TELEDYNE CONTINENTAL[®] AIRCRAFT ENGINE
SERVICE BULLETIN
Compliance Will Enhance Safety

SB94-3A
FAA APPROVED

SUBJECT: INDUCTION SYSTEM HOSE AND CLAMP REPLACEMENT

FIGURE 1

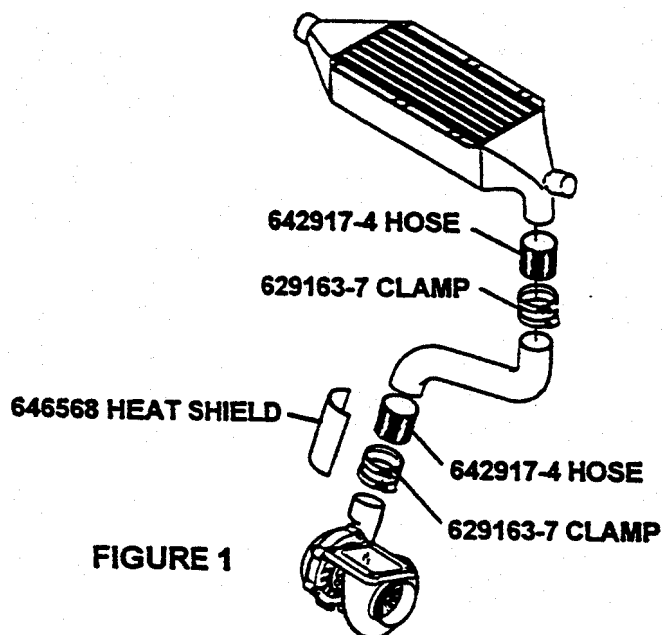
PURPOSE: Field reports indicate that there have been isolated instances of the P/N 642917-2 induction hose detaching from the induction tube due to improper positioning by maintenance personnel. Therefore, we have superseded the hoses and clamps with ones that have an increased length to improve the coupling of the induction system.

1. Remove engine cowlings and components necessary to gain access to the hoses and clamps that secure the left and right induction tubes located between the turbocharger compressor outlet and aftercooler inlet. See Figure 1. Reference the applicable airframe manufacturer's maintenance manual for cowlings and component removal and installation instructions.
2. Measure the four hoses and clamps and record their lengths. The old P/N 642917-2 hose has a length of 2.440 to 2.560 inches. The new P/N 642917-4 hose has a length of 2.940 to 3.060 inches. The old P/N 629163-5 clamp has a length of 1.870 to 1.890 inches. The new P/N 629163-7 clamp has a length of 2.370 to 2.390 inches.
3. Any of the four subject hoses or clamps that do not conform to the "new" hose and clamp dimensions listed in paragraph 2 must be replaced.

The following instructions must be accomplished on both the left and right induction tube hoses and clamps located between the turbocharger compressor outlet and aftercooler inlet. See Figure 1.

1. Loosen the worm screws on each clamp.
2. Position the hoses on the induction tube to facilitate the removal of the induction tube. Remove the induction tube and discard the old hoses, clamps and heat shield.

3. Clean the turbocharger compressor outlet, aftercooler inlet and induction tube with stoddard solvent and wipe clean with a dry cloth.
4. Install the new hoses P/N 642917-4, clamps P/N 629163-7 and heat shield P/N 646568 onto the induction tube.

5. Properly position the induction tube between turbocharger compressor outlet and the aftercooler inlet.
6. Position the hoses evenly on the parts to be coupled so that the space between the induction tube, turbocharger compressor outlet and aftercooler inlet is located in the center of the hose length. Properly position the heat shield.

7. Tighten each clamp evenly and torque to 35 to 45 inch pounds to insure positive sealing and retention of the hose. DO NOT over torque the clamp as this can result in damage to the clamp and/or hose.
